# HISTORIC AND DESIGN REVIEW COMMISSION

**HDRC CASE NO:** 2024-403  
**ADDRESS:** 422 PEREIDA ST  
**LEGAL DESCRIPTION:** NCB 932 BLK 1 LOT 6,7, & E 125 OF 9  
**ZONING:** C-3, H  
**CITY COUNCIL DIST.:** 1  
**DISTRICT:** King William Historic District  
**APPLICANT:** Jonathan Smith/smithdish architecture  
**OWNER:** David Uhler/BEETHOVEN MAENNERCHER INC  
**TYPE OF WORK:** Construction of a side addition and window replacement  
**APPLICATION RECEIVED:** November 25, 2024  
**60-DAY REVIEW:** January 24, 2025  
**CASE MANAGER:** Edward Hall

## REQUEST:

# BEETHOVEN HALLE RENOVATION concept

### North Elevation

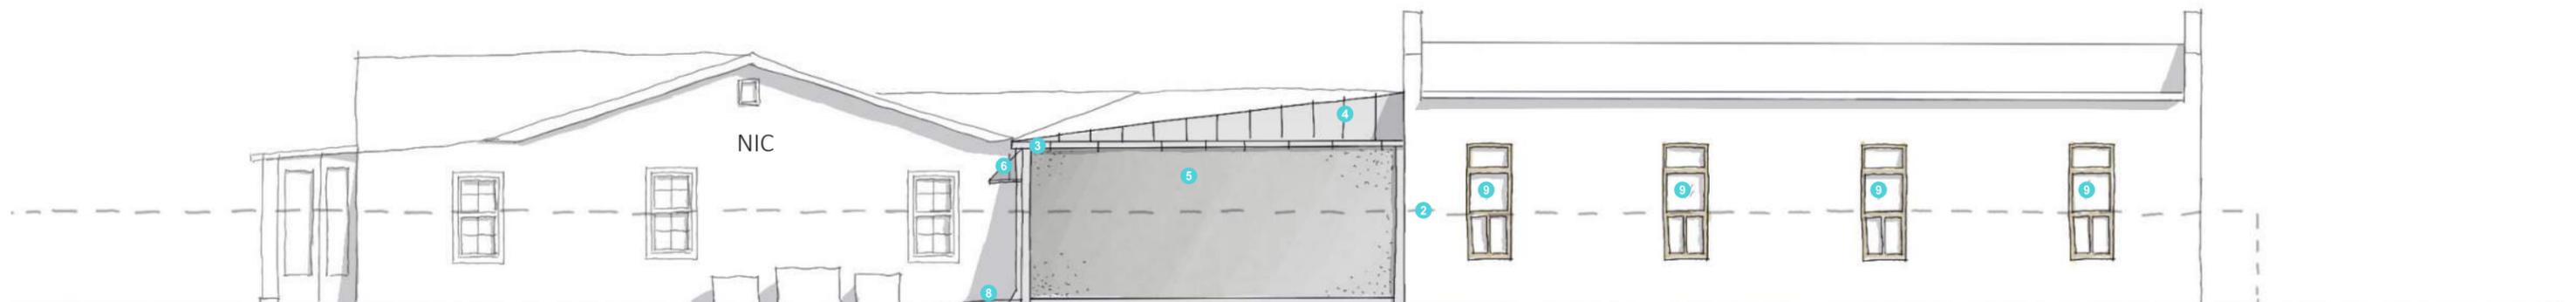
- e. ADDITION (Materials) – The applicant has proposed materials that includes a stucco façade, a standing seam metal roof, and fire rated doors. Generally, staff finds the proposed materials to be appropriate. Staff finds that the proposed stucco façade should feature a smooth, traditional finish. The proposed standing seam metal roof should feature smooth panels measuring 18 to 21 inches in width, a standard galvalume finish, and a crimped or munch ridge seam. Lastly, staff finds that the proposed double doors should be painted to match trim and other windows and doors on site.

1. Staff recommends conceptual approval of item #1, the construction of an addition based on findings c through f, with the following stipulations:
  - i. That the proposed stucco façade feature a smooth, traditional finish.
  - ii. That the proposed standing seam metal roof feature smooth panels measuring 18 to 21 inches in width, a standard galvalume finish, and a crimped or munch ridge seam.
  - iii. That the proposed double doors should be painted to match trim and other windows and doors on site.

## EXAMPLE ELEVATION OF NEW WINDOW

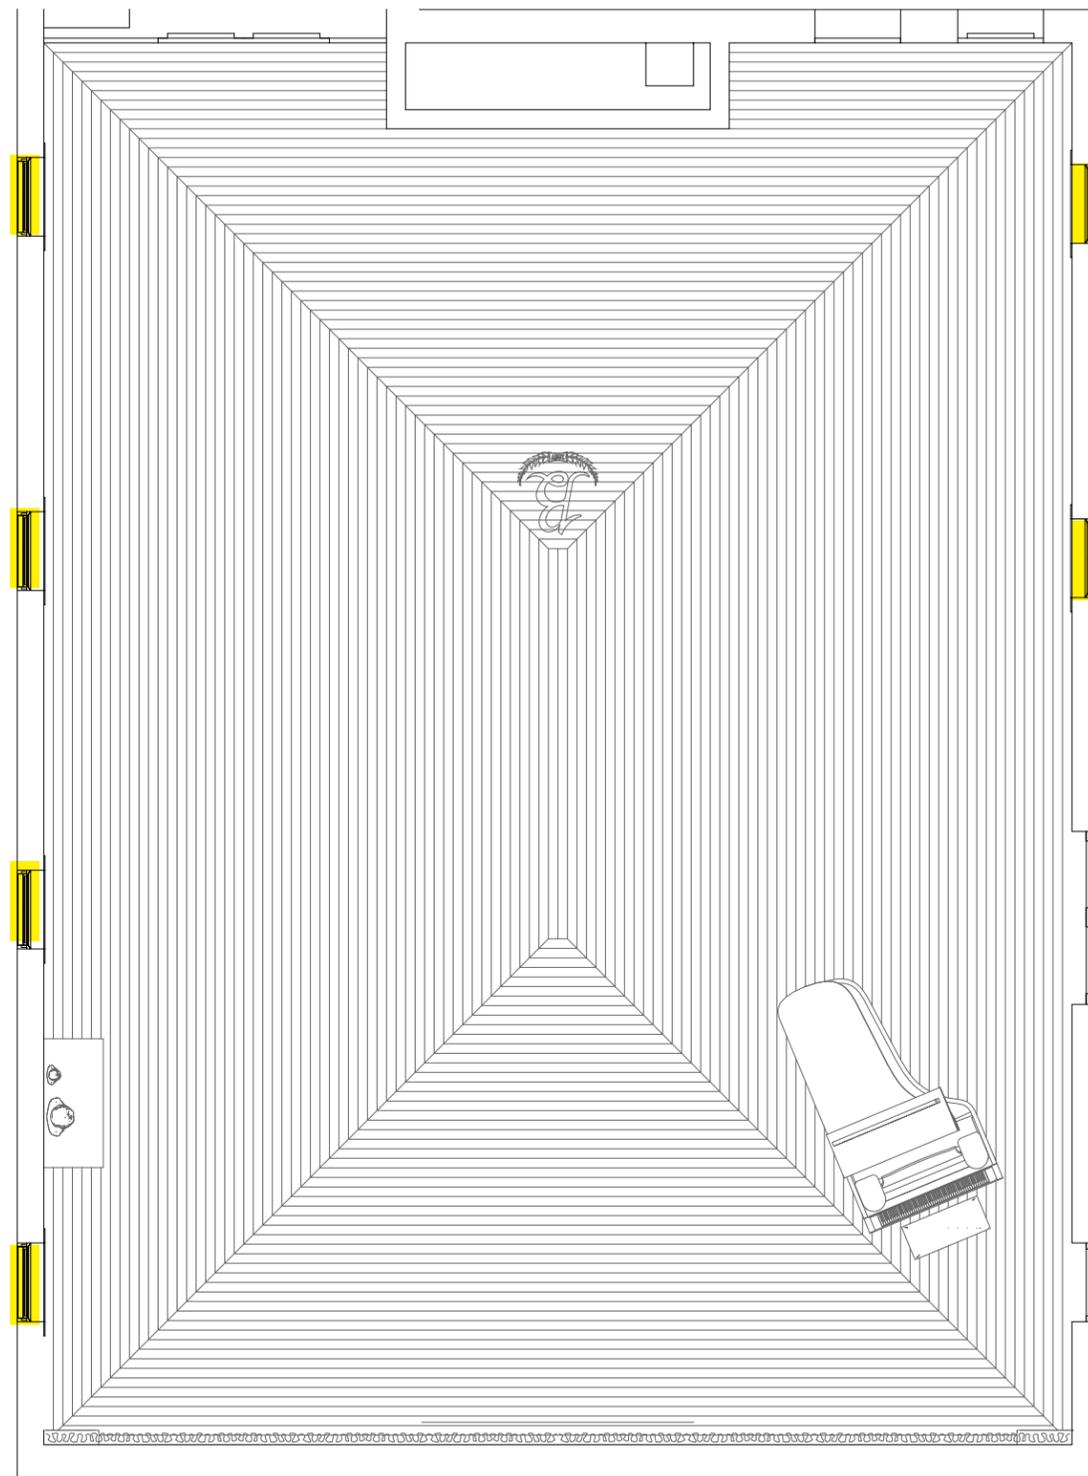
- g. WINDOW REPLACEMENT – Within the Halle, the applicant has proposed to replace six (6), non-original windows with new, double-hung wood windows. The applicant has noted that the existing, casement windows were installed in the 1980’s or 1990’s. The applicant has proposed to replace these non-original windows with

wood, four-over-four windows. The applicant has noted that the existing framed openings will not change. Staff finds the proposed window replacement to be appropriate. Staff finds that the proposed replacement windows should adhere to the adopted standards for window replacement.

2. Staff recommends conceptual approval of item #2, non-original window replacement, based on finding g, with the following stipulation:
  - i. That the proposed replacement windows adhere to the adopted standards for window replacement, as noted in finding g. The standards are noted above in the applicable citations.
